RE: Tree Protection Plan for Addition to Shriner's Hospital

Proposal: Shriners Hospitals for Children is planning a renovation and expansion of its facility at 3101 SW Sam Jackson Park Road, part of the OHSU Marquam Hill Campus. As illustrated on attached site plans, the proposed project includes:

File No.	LU 07-167389 EN
1/4 Section	3328,3428
Scale	1 inch = 300 feet
State_Id	1S1E09 200
Exhibit	B (Feb 27,2008)

MITIGATION PLAN

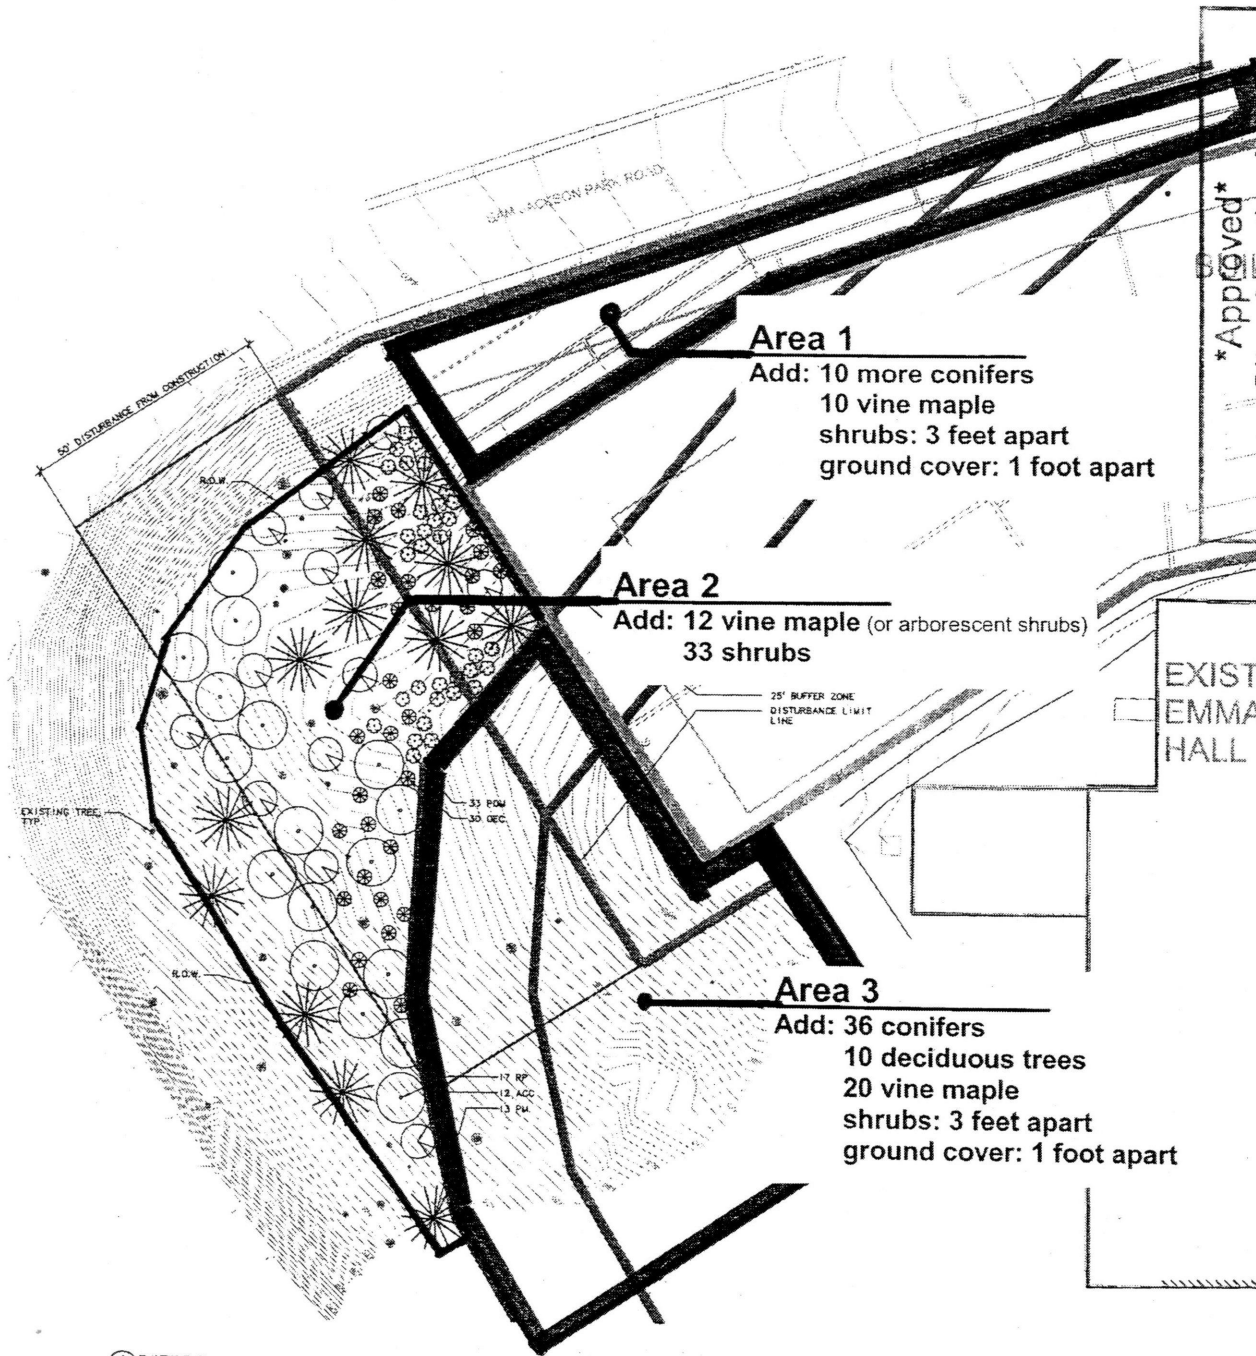
Area 1
 Add: 10 more conifers
 10 vine maple
 shrubs: 3 feet apart
 ground cover: 1 foot apart

Area 2
 Add: 12 vine maple (or arborescent shrubs)
 33 shrubs

Area 3
 Add: 36 conifers
 10 deciduous trees
 20 vine maple
 shrubs: 3 feet apart
 ground cover: 1 foot apart

1. A total of 30 trees, 42 shrubs, and 33 sword fern shall be planted, as proposed by the applicant and in substantial conformance with Exhibit C.4 Mitigation Plan (Area 2).

2. An additional 12 arborescent shrubs (or small trees) (western flowering dogwood, vine maple, western crabapple, common chokecherry, etc.), shall be planted as noted on Exhibit C.4 Mitigation Plan by BDS staff (Area 2).

3. An additional 33 native shrubs shall be planted, as noted on Exhibit C.4 Mitigation Plan by BDS staff (Area 2).
4. For continued compliance with Hearings Officer conditions of approval for LUR 92-00866 CU EN AD as shown on Exhibit D.9, 46 conifers, 10 deciduous trees, 30 vine maples, native shrubs planted 3 to 4 feet on center, and native ground covers planted one foot on center shall be added to the applicant's mitigation planting plan (Exhibit C.4 Areas 1 and 3).
